October 14, 2014

**Re: Proposed Residence of South Brookline 40B Development/Comments Regarding the Drainage Study for Hancock Village**

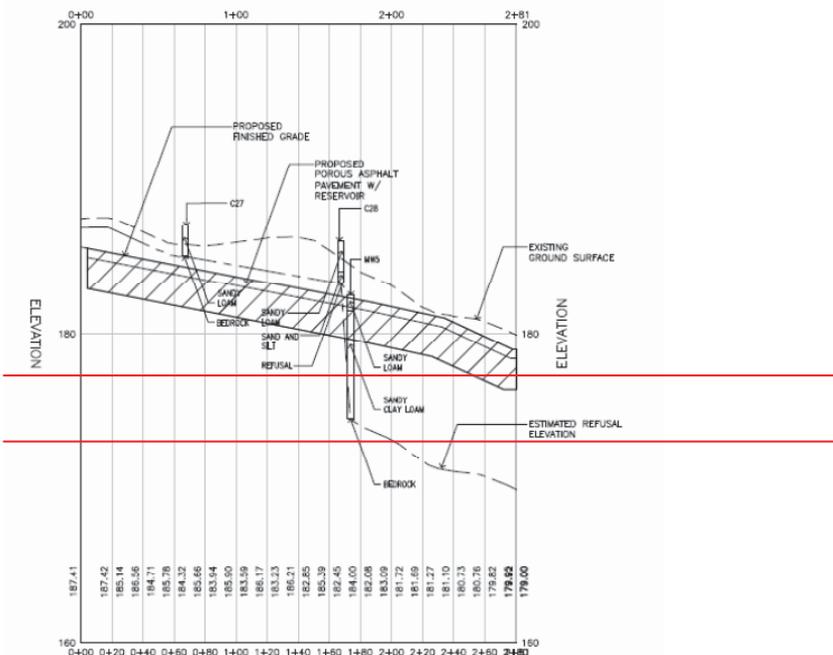
I'm a professional engineer working in Massachusetts and on my current project with the Massachusetts Department of Transportation (MassDOT), we have been discussing a drainage problem on a specific site. At two recent meetings the use of Stormceptors was presented as an alternative by the Contractor. In both instances, the possibility was rejected by MassDOT due to the poor performance of these systems. At one meeting, Stormceptors were referred to as "a waste of taxpayer's money" and would not be considered, even if the only alternative for treatment was to do nothing at all. The aversion to these systems displayed by MassDOT is a strong reason to prohibit them from this project.

### 3. Substorage Basin No. 4B will not work

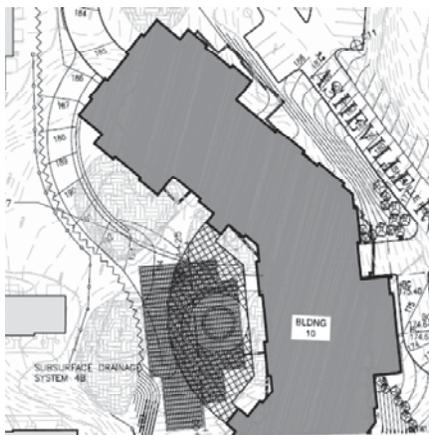
Substation Basin No. 4B is proposed to be constructed in the ledge adjacent to the residential tower.

This basin will be built by carving a tremendous area out of the puddingstone ledge. When complete, there will essentially be a deep “swimming pool” cut into the rock which will have plastic crates installed as a run-off storage system. The only way for water that is collected with the storage system to exit the storage system is through a small 6” pipe. This design has several fatal flaws:

- a. The model was run assuming the system was dry, so it had the maximum storage capacity available. However, once this system fills with water there will be no way for the water below the elevation of the outlet to drain. These systems were intended to be placed over soil, not rock as the design shows. The design should be run considering what would happen if two storm events would happen a few days apart. If this were done, the runoff calculations would show very different results.
- b. The six inch outlet pipe is dangerously small. Again, for MassDOT projects, the minimum pipe diameters allowed for drainage projects is twelve inches. This is to prevent clogging and system failures. Stantec said the pipe they are proposing was selected because “that’s what was needed.” I believe this answer is misleading. It

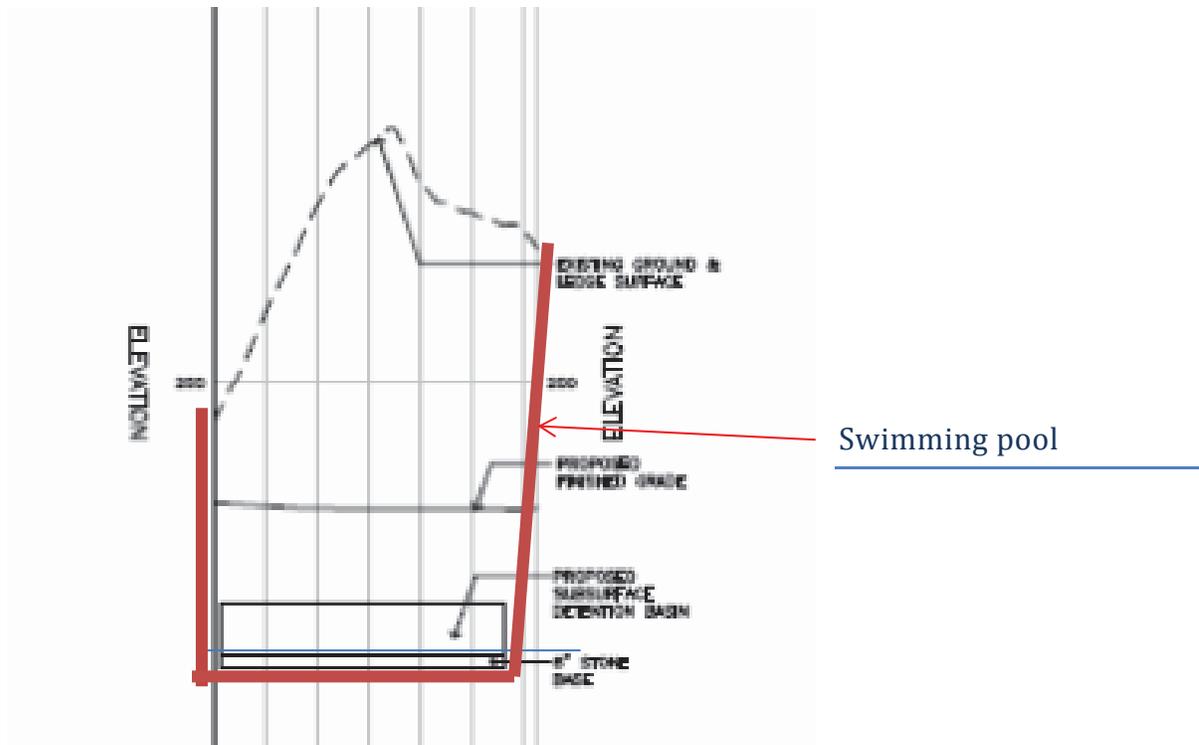
implies that a six inch pipe is what the system needed to operate properly and to provide a larger pipe would be wasteful. However, in actuality the six inch pipe is needed to choke the system to prevent water from leaving the storm tanks too soon. If a larger pipe were provided, it would allow too much water to enter the downstream system and not show the runoff being reduced. This is not an appropriate way to design a drainage system.

- c. The inability of the storage tanks to fully drain could result in water being trapped in the system and freezing. As such, the pressures developed by freezing water could destroy the flimsy plastic storm tank modules.
